<b>Gachsaran Polymer Industries Company</b> <b>HDPE Plant</b>		
	<b>Instruments Hookup Diagram and MTO</b>	 	
PO No.: GPIC-PT-MA-PO-000-3029	Document Number: VD-GPIC-MA-3029-3029-0051	Rev. 00	<b>Page 1 of 17</b>

## Instruments Hookup Diagram and MTO

Document Number: VD-GPIC-MA-3029-3029-0051

Page 3 of 17

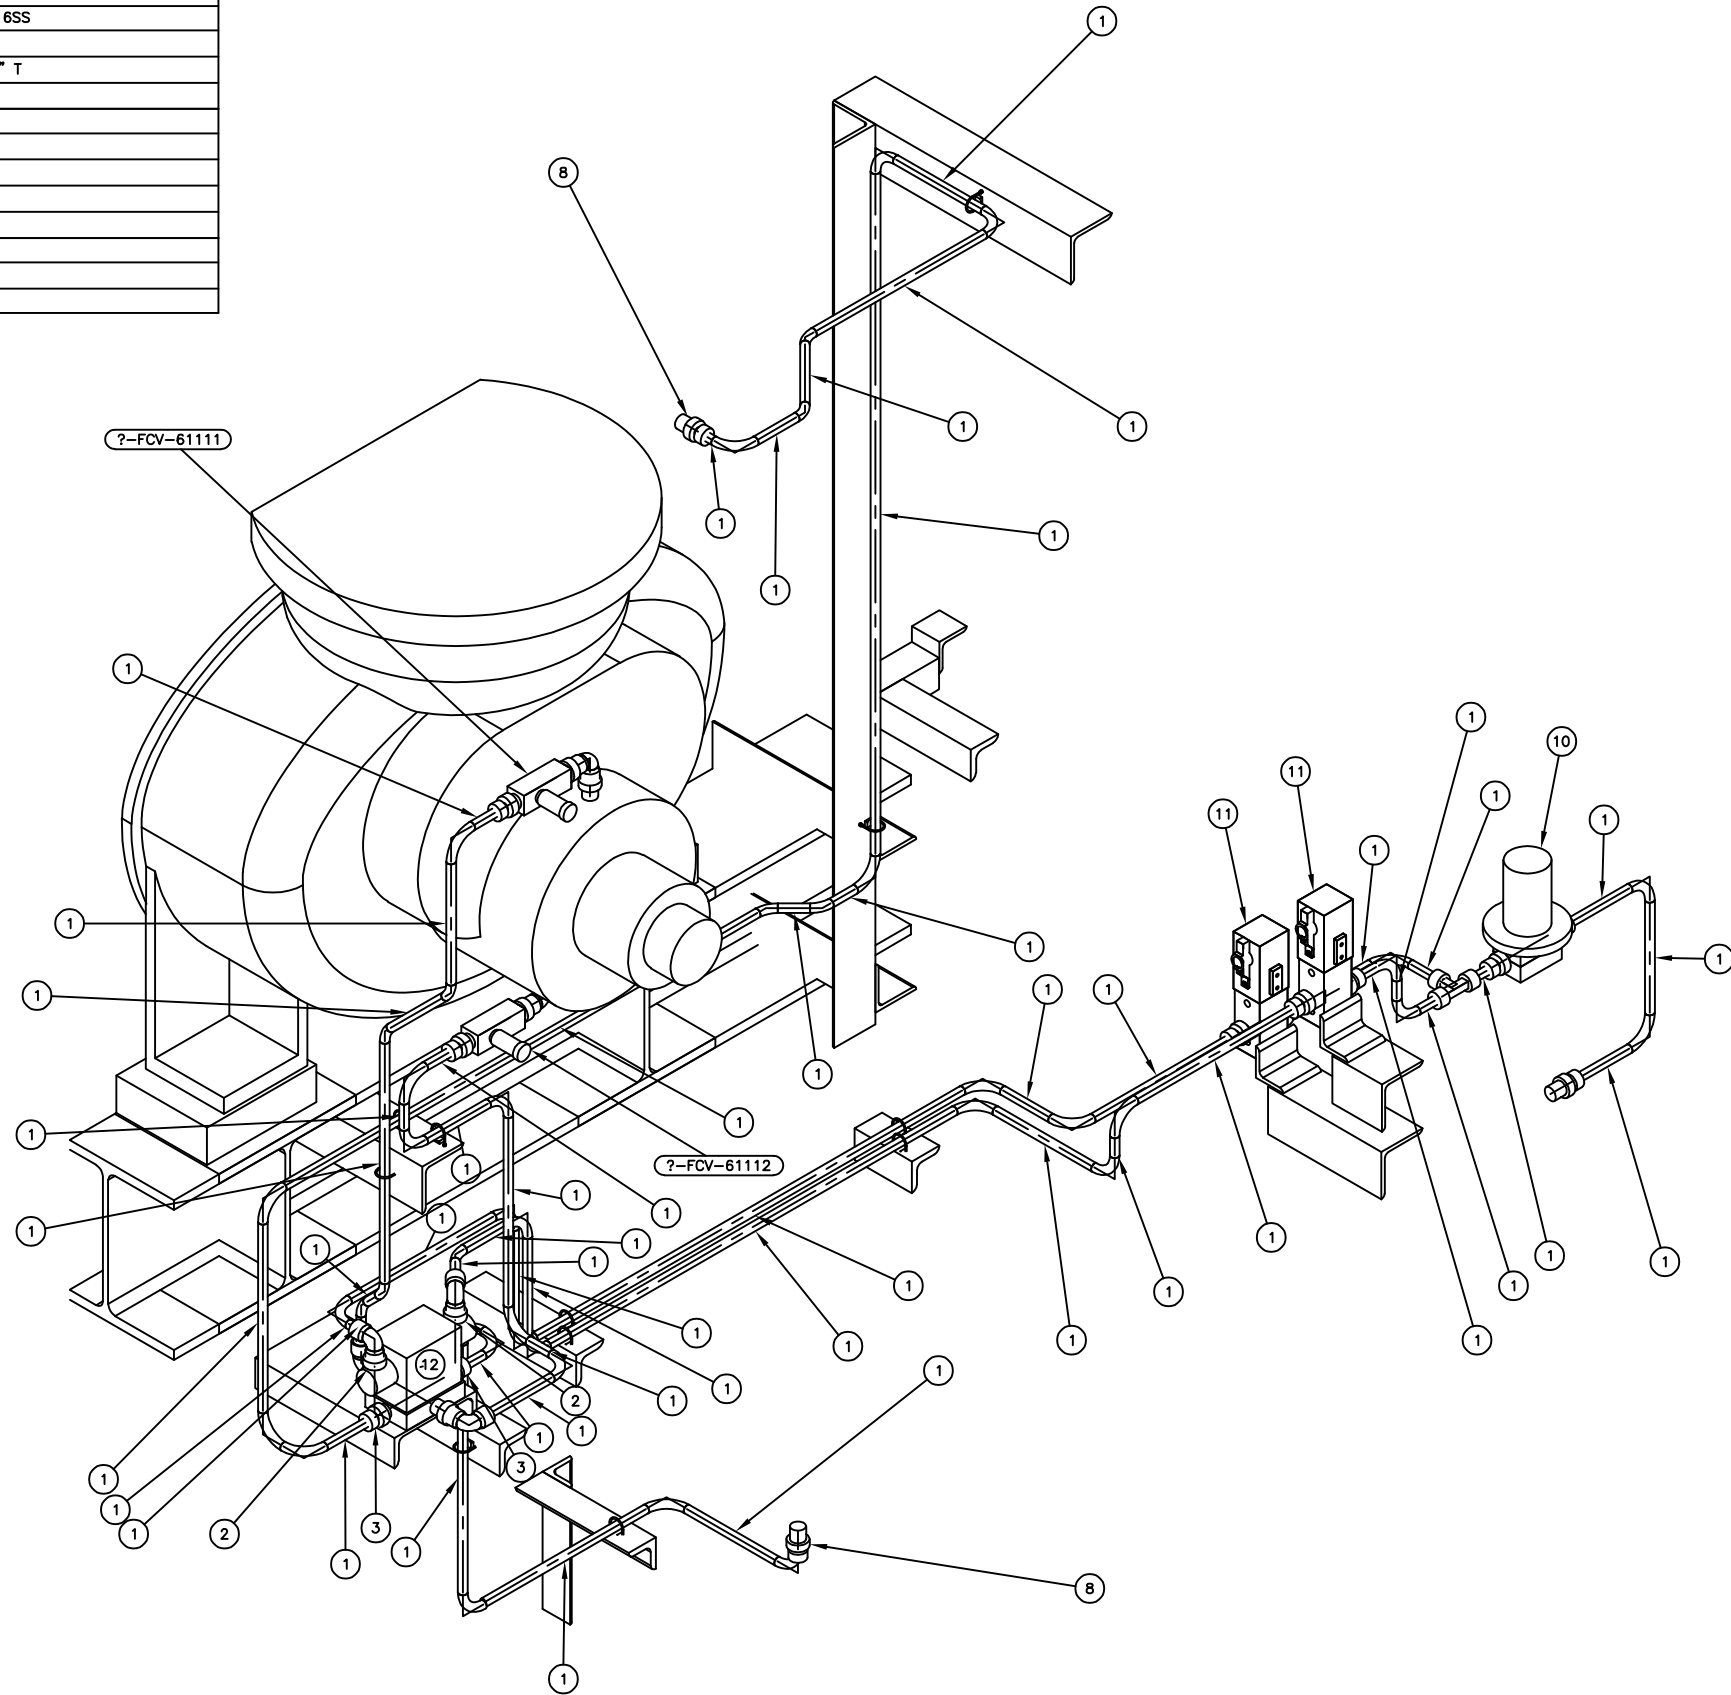
IN-01. All items of hookup material in the next sheets shall be mentioned in the below table.

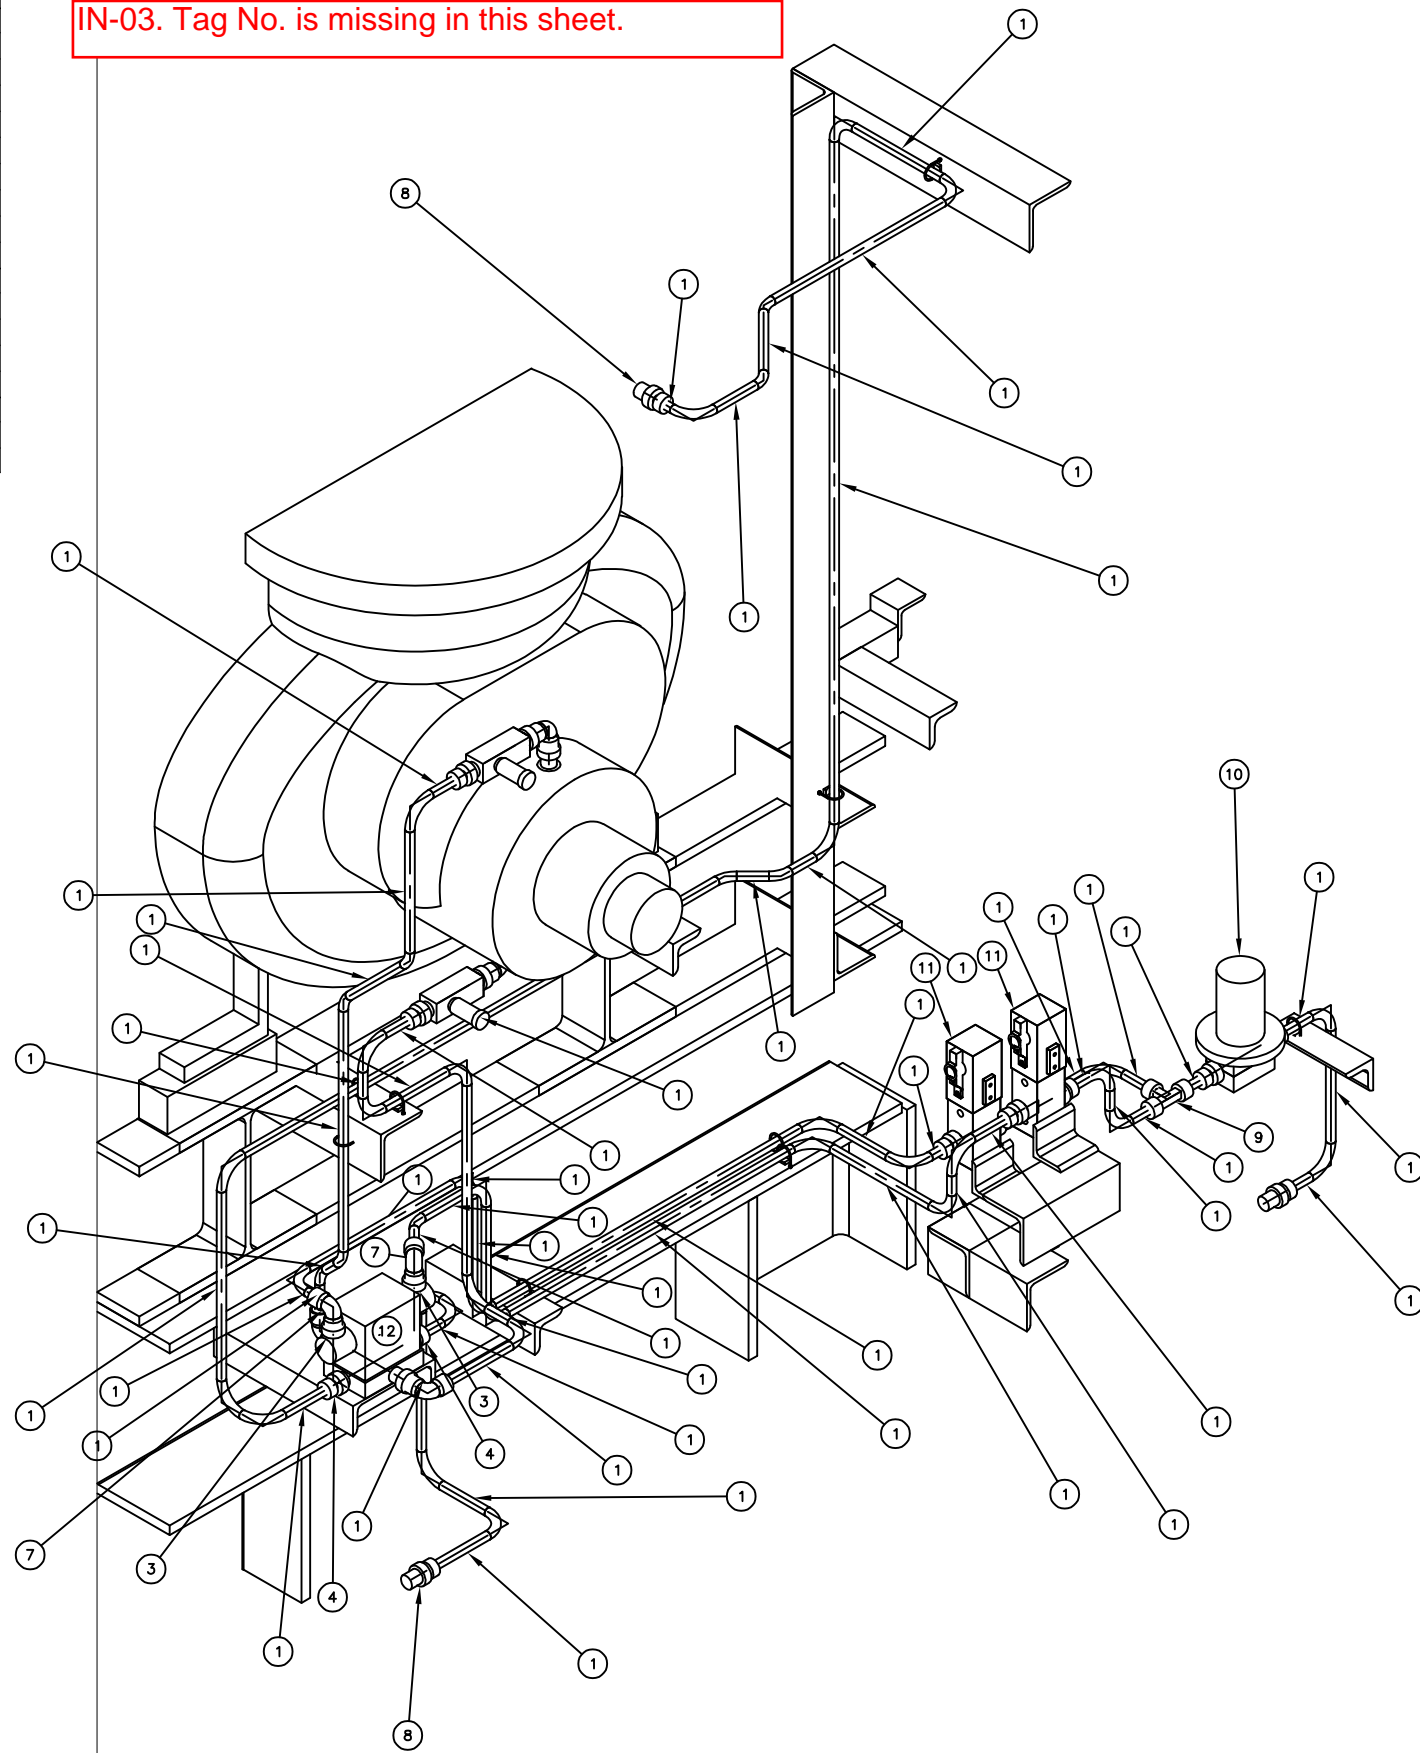
IN-02. Table of MTO is missing in this sheet.

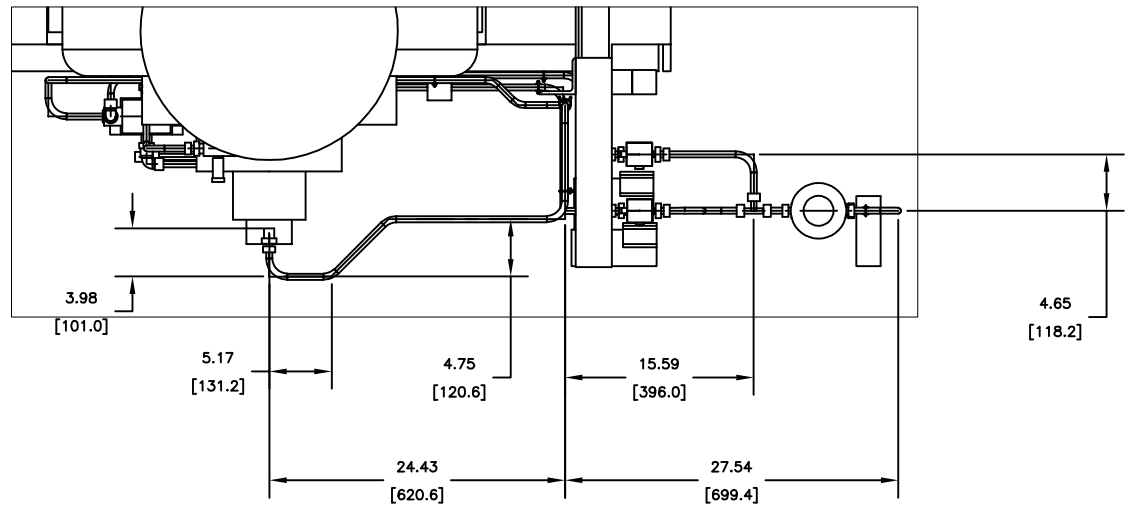
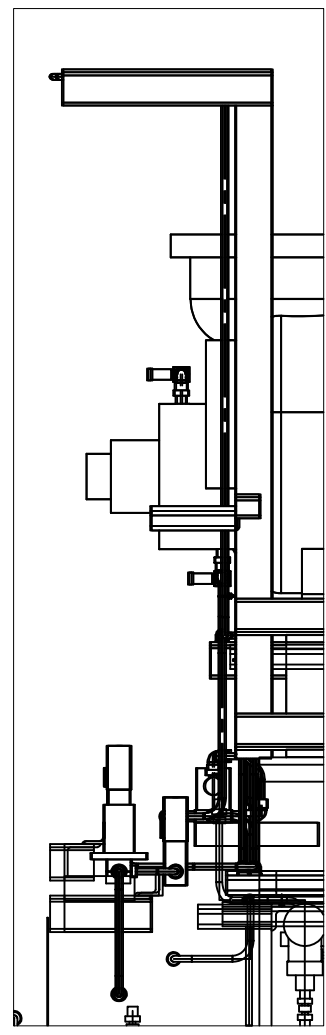
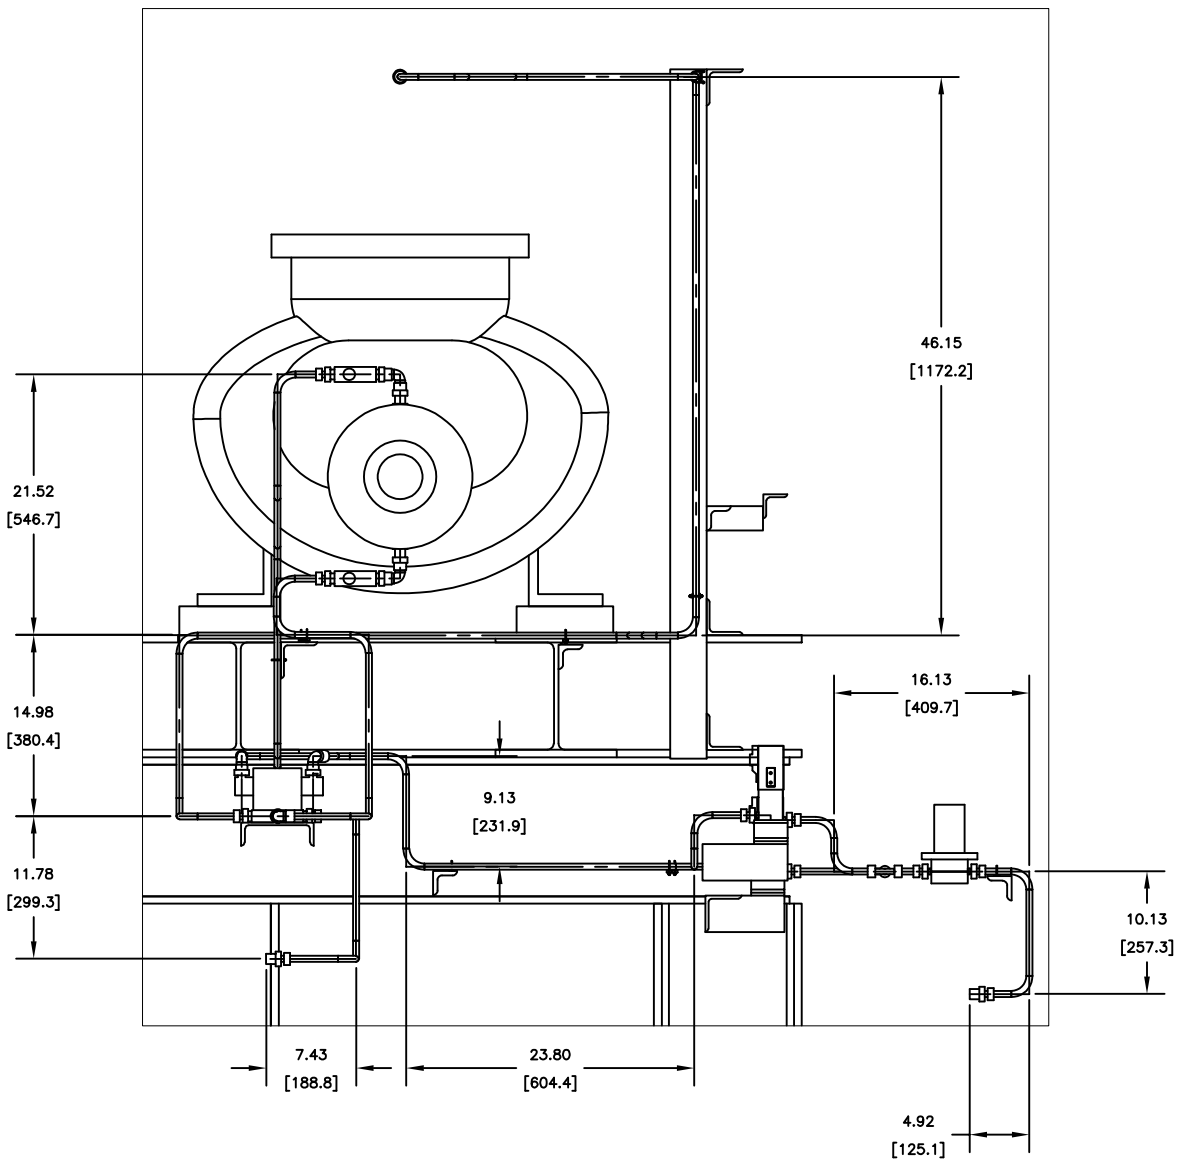
IN-03. Tag No. is missing in this sheet.

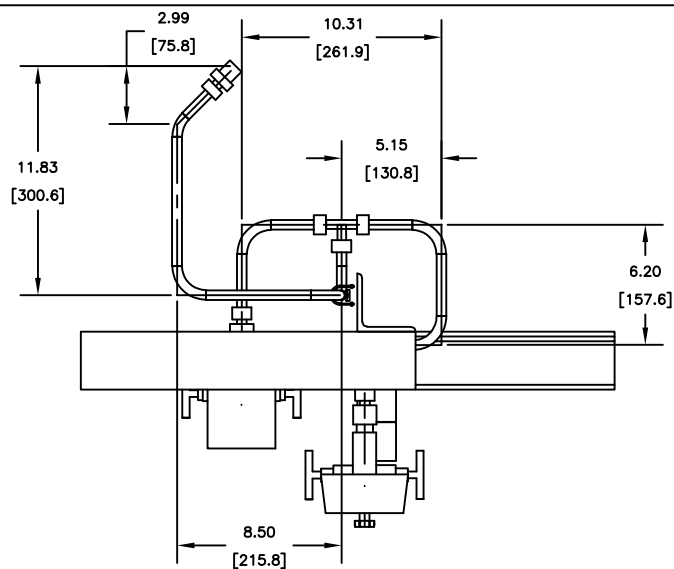
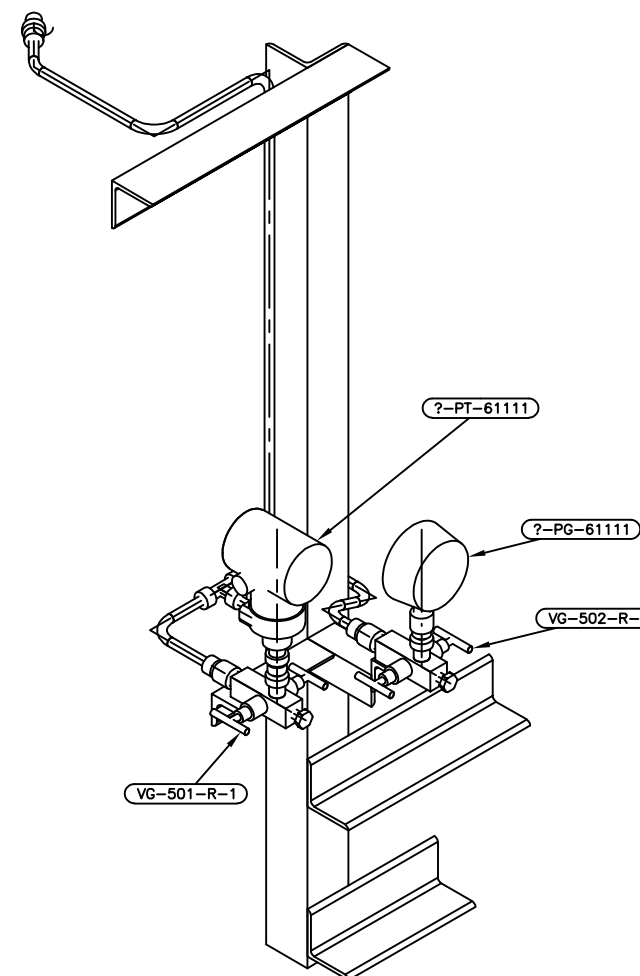
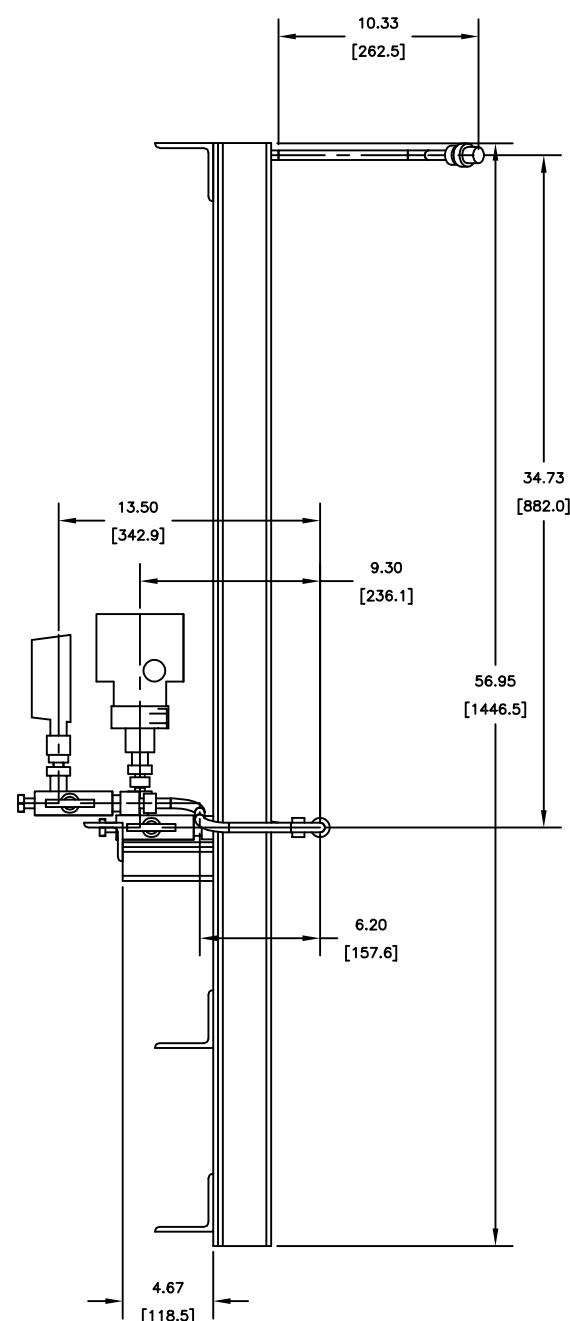
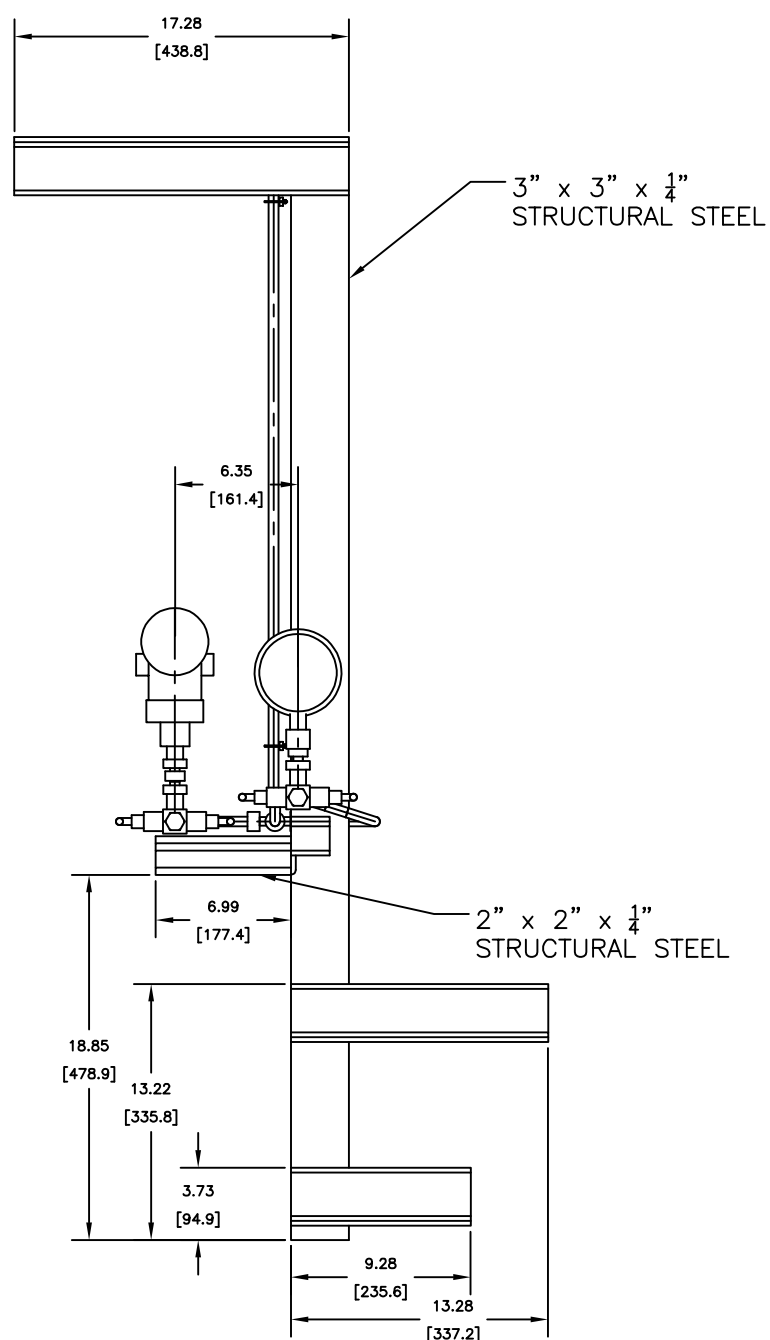
IN-04. Table of MTO and tag no. are missing in this sheet.
